**NEW MEXICO OIL CONSERVATION DIVISION**  
 - Engineering Bureau -  
 1220 South St. Francis Drive, Santa Fe, NM 87505

**ADMINISTRATIVE APPLICATION CHECKLIST**

Apache Corporation respectfully requests administrative approval for simultaneous dedication in the Blinebry Oil and Gas Pool and a non-standard 120 acre gas unit in the Tubb Oil and Gas Pool. The following wells, located in the SW $\frac{1}{4}$  of Section 27, Township 21 South, Range 37 East, N.M.P.M., Lea County, New Mexico (applicant's Marshall B Lease), are involved in this application:

**From:** Brooks, David K., EMNRD  
**Sent:** Wednesday, December 02, 2009 11:15 AM  
**To:** 'michelle.hanson@apachecorp.com'  
**Subject:** Marshall B; SD and NSP applications

**Tracts adjoining the SW/4 of Section 27**

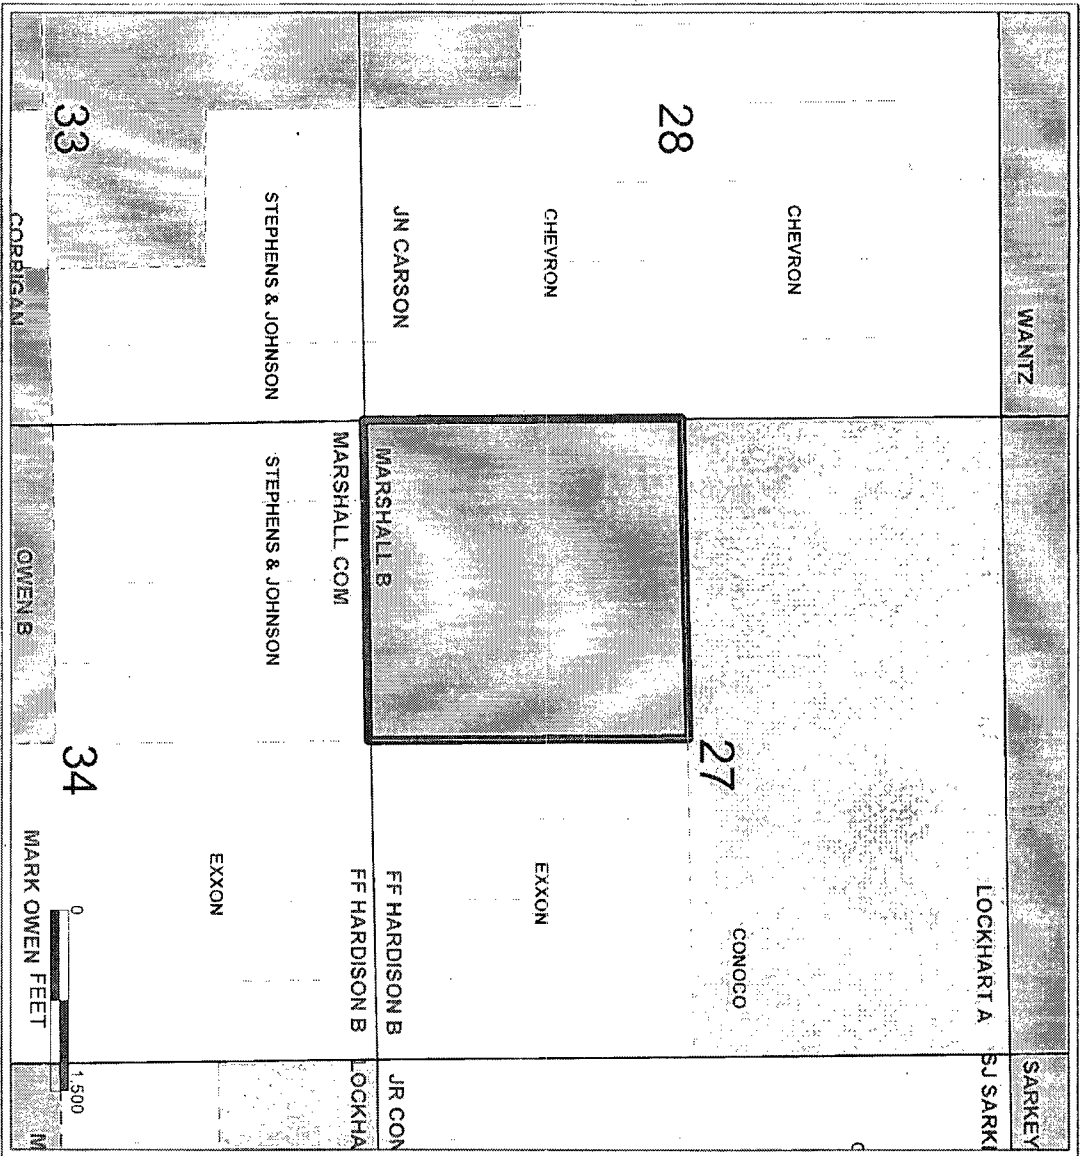
In order that I can be certain appropriate notices were given of this application, I would appreciate you furnishing us a plat depicting the units adjoining the SW/4 of Section 27, and indicating the operators or owners notified for each such unit.

In order that I can be certain appropriate notices were given of this application, I would appreciate you furnishing us a plat depicting the units adjoining the SW/4 of Section 27, and indicating the operators or owners notified for each such unit.

Please see attached Offset Owner list and plat. I notified John H. Hendrix and J.R. Cone and probably didn't need to since those parties are not in the adjoining tracts. I have sent in other Applications for the Mark Owen Lease, Walter Lynch Lease and Lou Worthan Lease. You may not have these applications in hand yet, but I'm sure you are going to need this information for those Leases as well so I will work on getting you further information. I apologize for not providing this information with the applications. I have never done an application before so I greatly appreciate your patience and thank you for your help.
